State of New Mexico
Energy, Minerals and Natural Resources

Form C-103
Revised July 18, 2013

WELL API NO. 30-015-37468
5. Indicate Type of Lease STATE <input checked="" type="checkbox"/> FEE <input type="checkbox"/>
6. State Oil & Gas Lease No.
7. Lease Name or Unit Agreement Name Myox 6 State Com
8. Well Number #12H
9. OGRID Number 229137
10. Pool name or Wildcat Hay Hollow; Bone Spring

SUNDRY NOTICES AND REPORTS ON WELLS
(DO NOT USE THIS FORM FOR PROPOSALS TO DRILL OR TO DEEPEN OR PLUG BACK TO A DIFFERENT RESERVOIR. USE "APPLICATION FOR PERMIT" (FORM C-101) FOR SUCH PROPOSALS.)

CURRENT WELL SKETCH

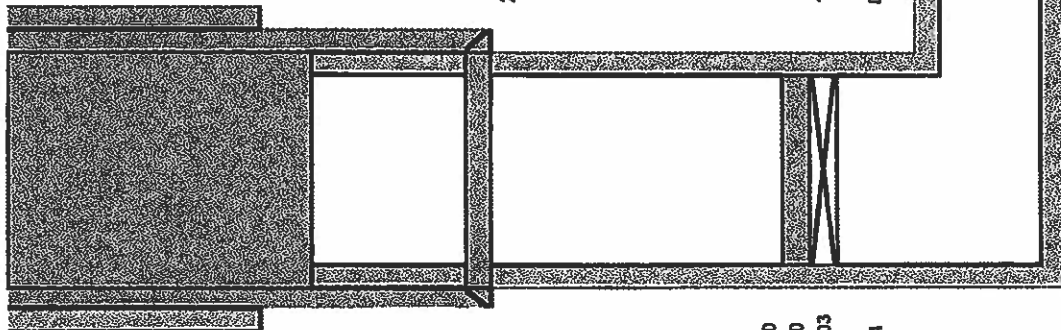
- 60
- Set 5 1/2" CIBP @ 5800'. Circ well w/ MLF. Pressure test csg. Spot ~~25~~ sx cmt @ 5800-5800'. WOC & tag - Must tag @ 5300'
 - Perf & Sqz 60 sx cmt @ 2331-2085'. WOC & Tag (9 5/8" csg & B/Salt)
 - Perf & Sqz 110 sx cmt @ 500' to surface. (T/Salt & 13 3/8" Shoe)
 - Cut off well head, verify cmt to surface, weld on Dry Hole Marker. Must wait 4 hrs after cmt before cut off
